From: Haney, Jeremy NFG NG ORARNG (USA) <jeremy.haney2.nfg@army.mil>
Sent: Monday, April 1, 2024 11:45 AM
To: WOODY Jennifer L * WRD
Cc: CLEMENTS Allen * DEQ; FARRIS Ann M * DEQ; Leeper, Mark S CIV USARMY HQDA (USA); Kelly Toynton; Leake, Benjamin
Subject: RE: Review process for Umatilla Depot Artificial Recharge Limited License-1964 application and model

OMD has reviewed the *Umatilla County Central Area Artificial Recharge Project* Limited License Application and accompanying *Numerical Groundwater Modeling to Evaluate the Effect of Artificial Recharge on a Groundwater Pump and Treat System, Former Umatilla Army Depot, Umatilla County, Oregon*. While the AR project could benefit to the Ordnance Aquifer and the area, there is insufficient information to fully assess potential negative impacts to the Explosive Washout Lagoon remediation project. OMD has the following questions and comments:

Umatilla Artificial Recharge Application Comments

Umatilla Artificial Recharge Model Comments

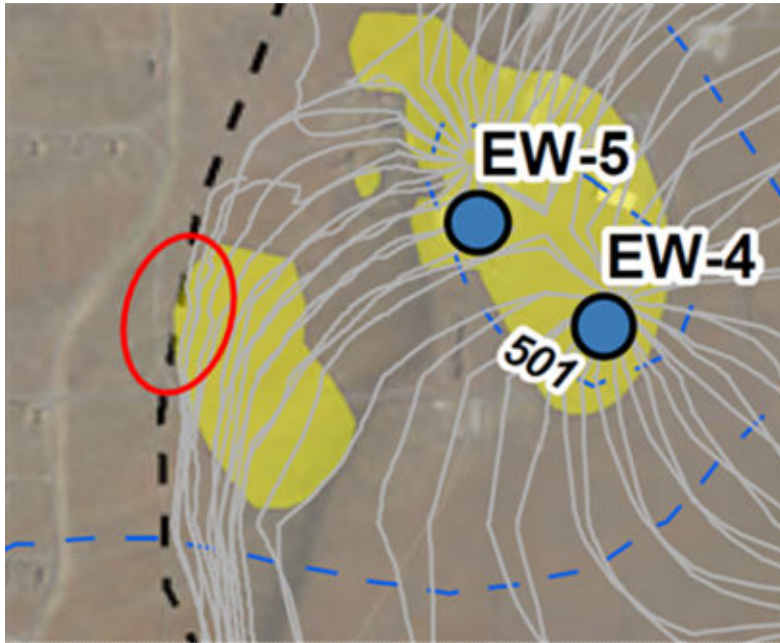
22) Section 2.1: Groundwater elevation data is available for the model simulated years (2018 to 2022) in the vicinity of the EWL. How do the modeled groundwater elevations and elevation contours compare to measured elevations and interpreted groundwater elevation contours?

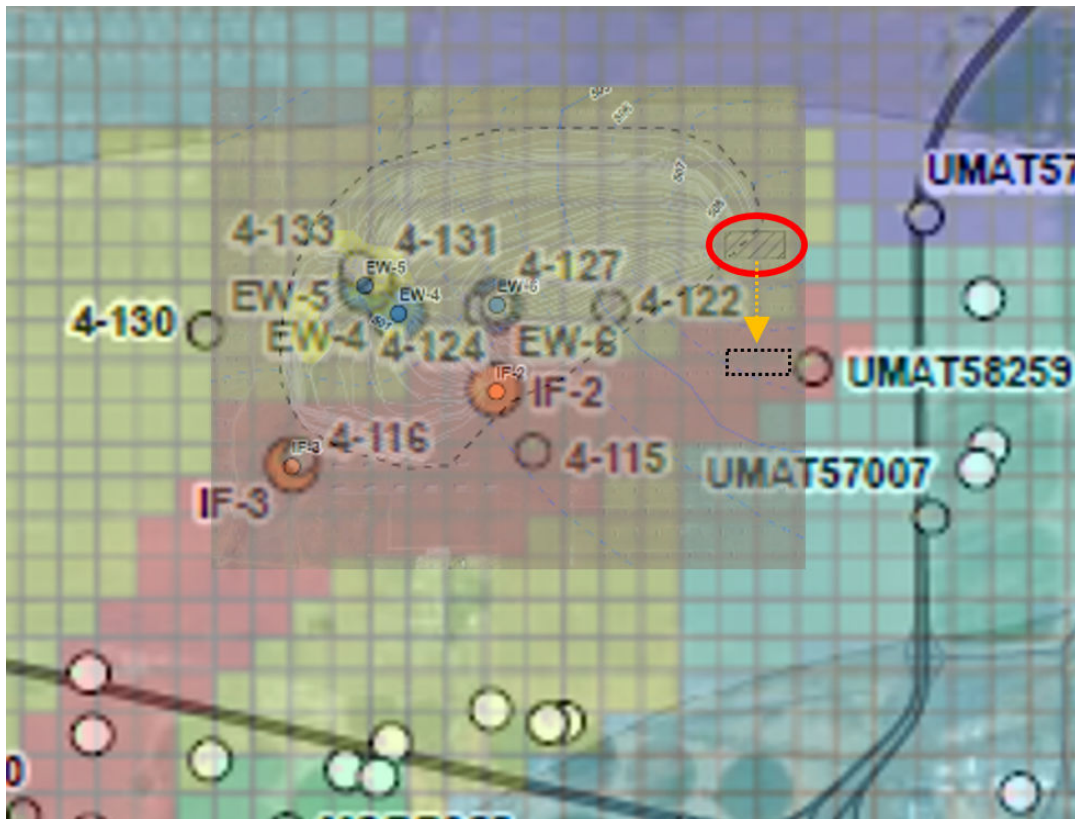
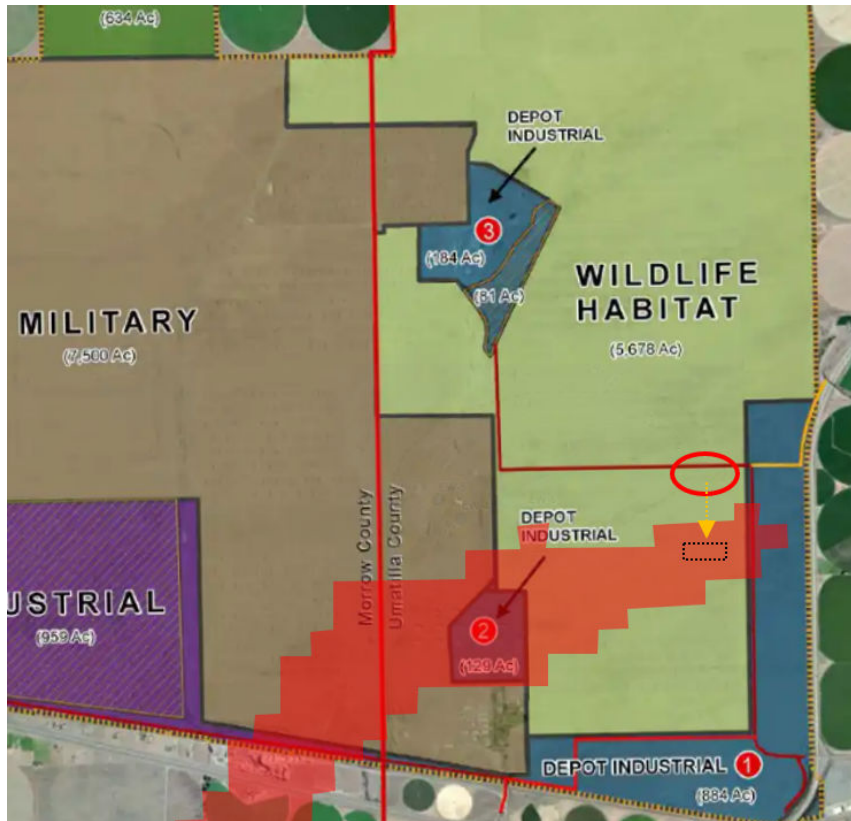
- 31) Section 4: The groundwater model calibration is greater than 15.1% in the vicinity of the EWL extraction wells and is not sufficiently calibrated to meet objective 4 of this groundwater modeling evaluation. Model resolution within the EWL area is low (each cell is 14.7 acres). The model in its current iteration is not sufficient to evaluate potential the AR project could negatively affect the EWL plume by pushing the plume west beyond the modeled capture zone. Figure 2 suggest the modeled capture zone no longer encompasses the EWL plume during AR (see screenshot below).

32) Relocating the AR project recharge site could reduce the potential for the AR project to cause EWL plume migration beyond the modeled GETS capture zone and potentially allow for higher AR rates after the initial assessment. For example, moving the AR project recharge site approximately 2,000 to feet (roughly 3 model cells) south would allow infiltration into the area of highest hydraulic conductivity, as modeled. Are there plans reevaluate the model with the AR project recharge site at alternate location(s) with higher modeled hydraulic conductivity to assess effects on the EWL? (see screenshots below, for illustrative purposes only. NOTE: because more comprehensive figures were not present in the report, I had to layer screenshots of figures, so positions are approximate. Figure 1 and 3 boundaries matched up as did well locations on Figures 1, 2, and 3).
